FIRST AMENDMENT CONTRACT 2012-P00080 A

RENEWABLE POWER PURCHASE AND OPERATING AGREEMENT BETWEEN
WINDMAR RENEWABLE ENERGY, INC. AND
THE PUERTO RICO ELECTRIC POWER AUTHORITY

WHEREAS: SELLER and PREPA executed on February 23, 2012 a Renewable Power Purchase and Operating Agreement (Agreement), for the development of a 20 MW photovoltaic solar energy system in the vicinity of Yauco-Guayanilla, Puerto Rico; and

Figure 1 Voltage Ride-Through Requirements

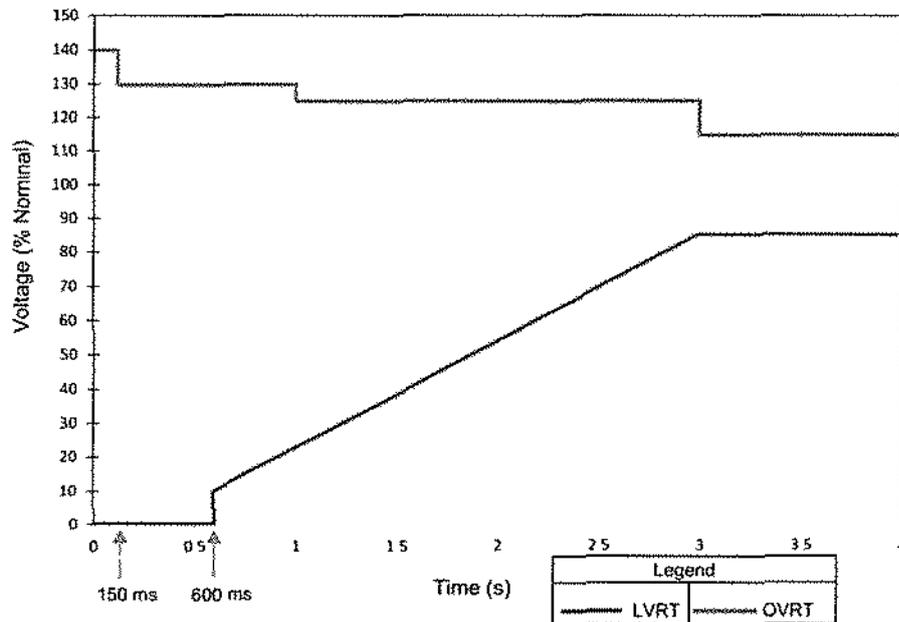
- W
- From Figure 1, PREPA requires all generation to remain online and be able to ride-through three phase and single phase faults down to 0.0 per-unit (measured at the point of interconnection), for up to 600 ms.
 - All generation remains online and operating during and after normally cleared faults on the point of interconnection.

- iii. All generation remains online and operating during backup-cleared faults on the point of interconnection.
 - iv. During the low voltage fault conditions, the PV facility shall operate on reactive current injection mode. This mode of operation shall be implemented with a reactive current droop characteristic which shall have an adjustable slope from 1 to 5%. A dead band of 15 % is required.
- b. PREPA's Overvoltage Ride-Through (OVRT) Requirements:
- i. PREPA requires all generation to remain online and able to ride-through symmetrical and asymmetrical overvoltage conditions specified by the following values illustrated in Figure 1:

Overvoltage (pu)	Minimum time to remain online
1.4 – 1.3	150 ms
1.3 – 1.25	1 s
1.25 – 1.15	3 s
1.15 or lower	indefinitely

Figure 2 Reactive Power Capability Curve

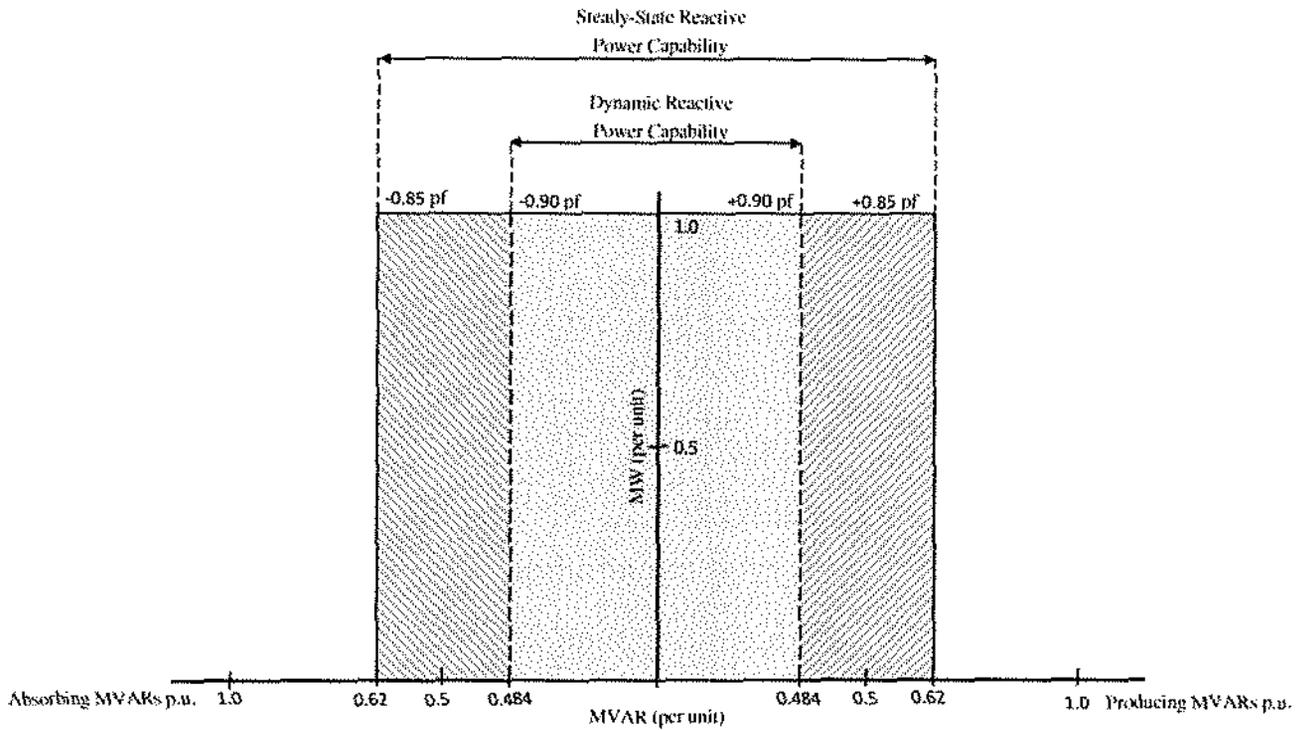
The +/- 0.90 power factor range should be dynamic and continuous at the point of interconnection (POI). This means that the PVF has to be able to respond to power system voltage fluctuations by continuously varying the reactive output of the plant within the specified limits. The previously established power factor dynamic range could be expanded if studies indicate that additional continuous, dynamic compensation is required. It is required that the PVF reactive capability meets +/- 0.85 Power Factor (PF) range based on the PVF Aggregated MW Output, which is the maximum MVar capability corresponding to maximum MW Output. It is understood that positive (+) PF is where the PVF is producing MVar and negative (-) PF is where the PVF is absorbing MVar.

This requirement of MVar capability at maximum output shall be sustained throughout the complete range of operation of the PVF as established by Figure 2.
